Norfolk Vanguard Offshore Wind Farm

Additional Mitigation

Department for Business, Energy and Industrial
Strategy (BEIS) Request for information

Document Reference: ExA; Mit; 11.D10.2
Date: 28 February 2020
Author: Royal HaskoningDHV

Figure 3.1 Cable protection locations to be assessed in the assessment of effects of habitat loss on Annex 1 Reef

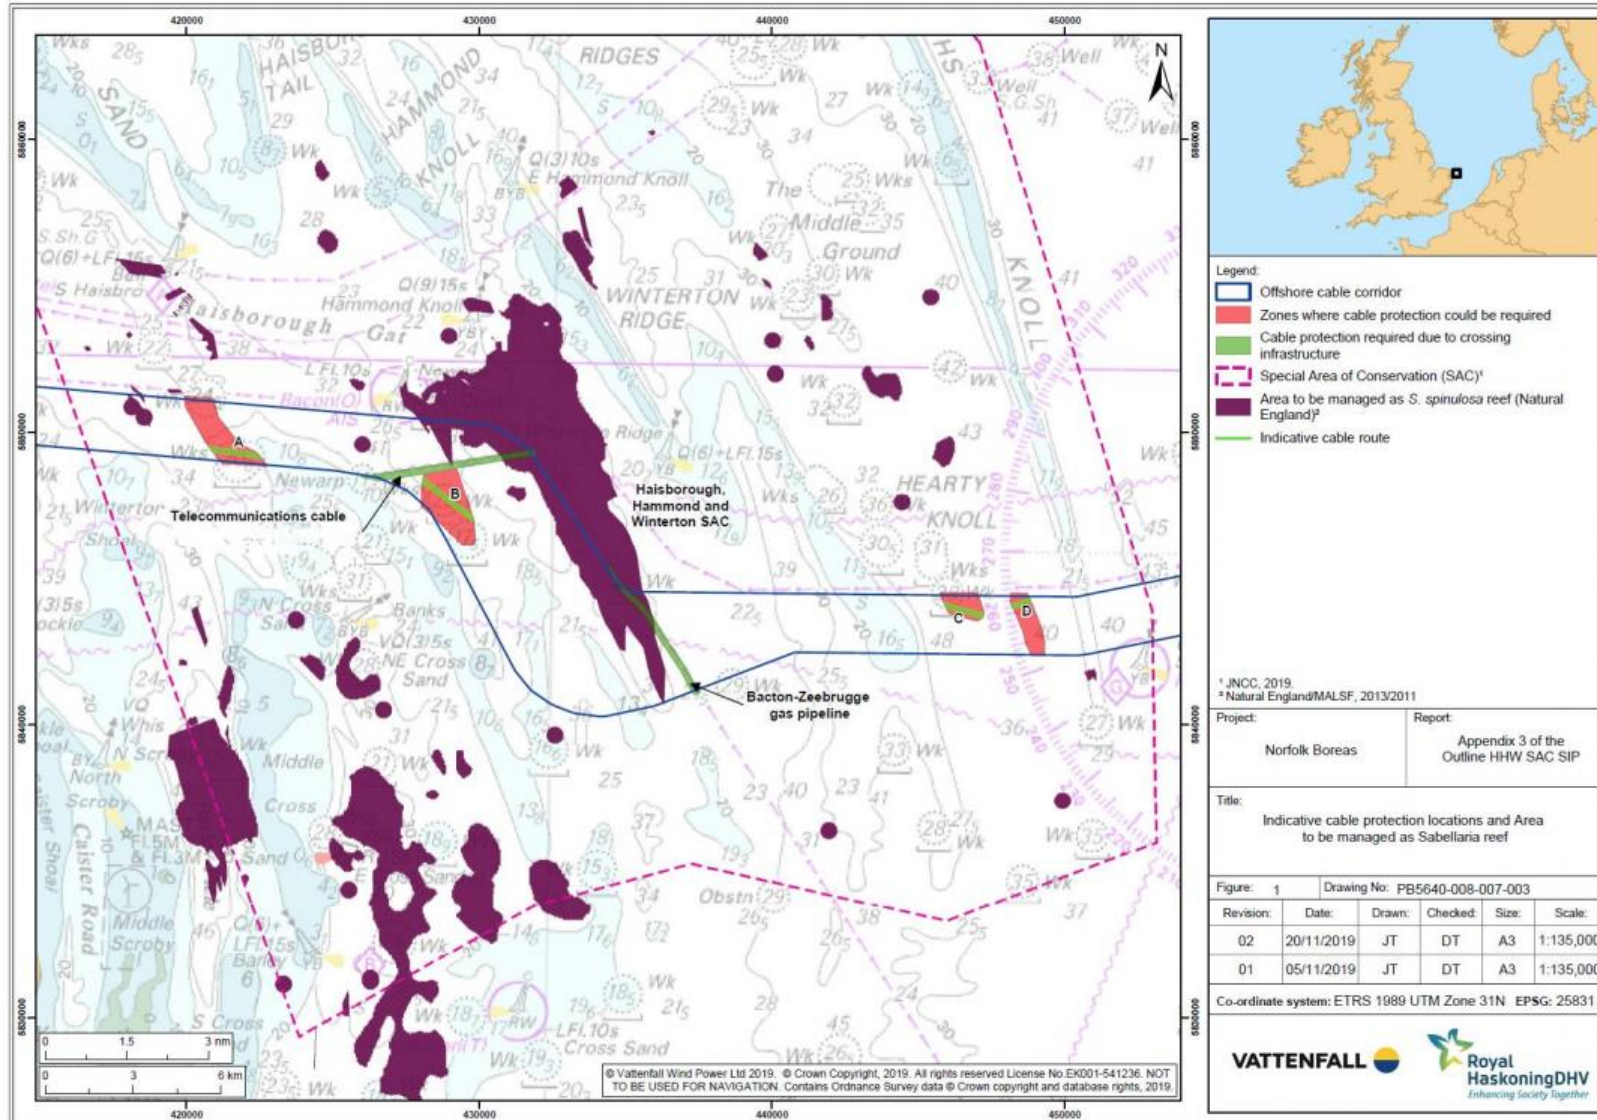
37. In response to the BEIS letter, the Applicant is proposing a new commitment to use no cable protection in the priority areas to be managed as reef within the HHW SAC, unless otherwise agreed with the MMO in consultation with NE.

38. The areas to be managed as reef (shown in Figure 3.1) have been identified by NE as areas where *Sabellaria spinulosa* reef has been recorded in the past and therefore may have potential to recover if pressures are removed. Two of the areas to be managed as reef have been identified as priority areas and these underpin proposed fisheries management measures that are being progressed by the Eastern Inshore Fisheries and Conservation Authority (EIFCA) and Department of Food, Environment and Rural Affairs (DEFRA).

39. This commitment will ensure there is no habitat loss in the priority areas that have been identified in order to facilitate the recovery of the *Sabellaria* reef feature to favourable condition. By committing to avoid cable protection in these priority areas, the Applicant is ensuring that any habitat loss within the SAC (outside of the priority areas to be managed as reef) would not hinder the recovery target for Annex 1 Reef and would have no Adverse Effect on Integrity (AEoI) of the HHW SAC due to the small scale of loss. This is in accordance with the Natural England advice note regarding consideration of small scale habitat loss within Special Areas of Conservation (SACs) in relation to cable protection (submitted at Deadline 4 of the Norfolk Vanguard Examination, REP4-062).

40. To provide confidence that cable protection will not be required in the priority areas to be managed as reef, evidence is provided in Appendix 3 of the HHW SAC control document (document 8.20)⁷ submitted on 28 February 2020 of the most likely areas where cable protection would be required (if required at all). Figure 3.1 (an extract from Appendix 3 of the HHW SAC control document) shows that there is no overlap between the most likely areas where cable protection could be required and the areas to be managed as reef.
